Access Compliance Report

Public Rights-of-Way

Intersection ID: 12160	Main Street: E_9TH_ST	Cross Street: N_BREVARD_ST	Location: S
ADA ID: FF368B769378	Ramp Type: PerpDiag	Initial Pass/Fail: Fail	Overall Compliance: No
		Severity Score: 8.75

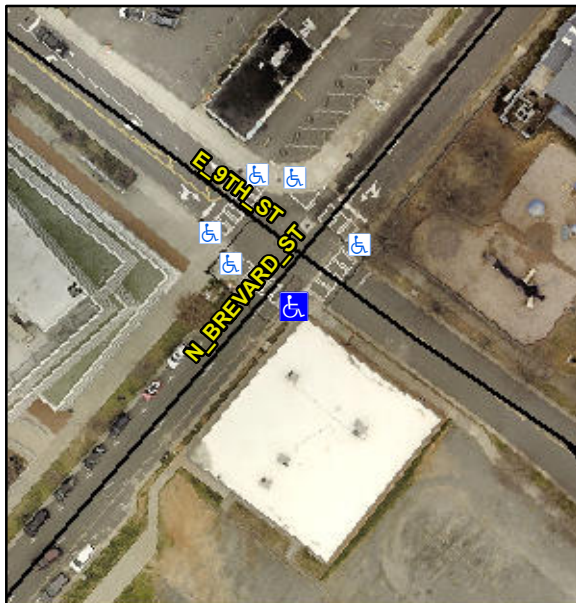
Compliance	Description	Data	Compliance	Description	Data
N/A	Ramp Length (in)	72.0	Yes	Ramp Slope (%)	7.7
No	Ramp Width (in)	47.0	Yes	Ramp XSlope (%)	0.0
N/A	Flare Type LT	N/A	N/A	Flare Type RT	N/A
N/A	Flare Slope LT (%)	N/A	N/A	Flare Slope RT (%)	N/A
N/A	Flare Traversable LT?	N/A	N/A	Flare Traversable RT?	N/A
N/A	Landing Length (in)	N/A	N/A	DWS Provided?	N/A
N/A	Landing Width (in)	N/A	N/A	DWS Contrast?	N/A
N/A	Landing Slope (%)	N/A	N/A	DWS Length (in)	N/A
N/A	Landing X Slope (%)	N/A	N/A	DWS Full Width?	N/A
N/A	Landing Curb? (Y/N)	N/A	N/A	DWS Offset (in)	N/A
N/A	Shared Landing?	N/A			
N/A	Gutter Ponding?	N/A	N/A	Gutter Slope (%)	N/A
N/A	Gutter Lip Ht (in)	N/A	N/A	Gutter X Slope (%)	N/A
N/A	Painted X Walk1?	Yes	N/A	Painted X Walk2?	Yes
	X Walk 1 Direction	To NE		X Walk 2 Direction	To NW
N/A	X Walk 1 Width (in)	115.0	N/A	X Walk 2 Width (in)	117.0
	X Walk 1 Slope (%)	5.4		X Walk 2 Slope (%)	3.3
	X Walk 1 X Slope (%)	1.6		X Walk 2 X Slope (%)	1.3

N/A	Ramp inside XWalk1?	Yes	N/A	Ramp inside XWalk2?	Yes
	Road Slope (%)	1.6	N/A	Clear Space?	N/A
	Road X Slope (%)	3.9	N/A	Clear Space to XWalk (in)	N/A
N/A	Any Obstructions?	N/A	N/A	Storm Grate/Utility Hazard?	N/A
	Obstruction Type			Storm Grate/Utility Type	
		N/A			N/A
			Yes	Surface Condition? (G/P)	Good

Remove & Replace Curb Ramp With Two New Directional Ramps or Equivalent.

R304.5.1
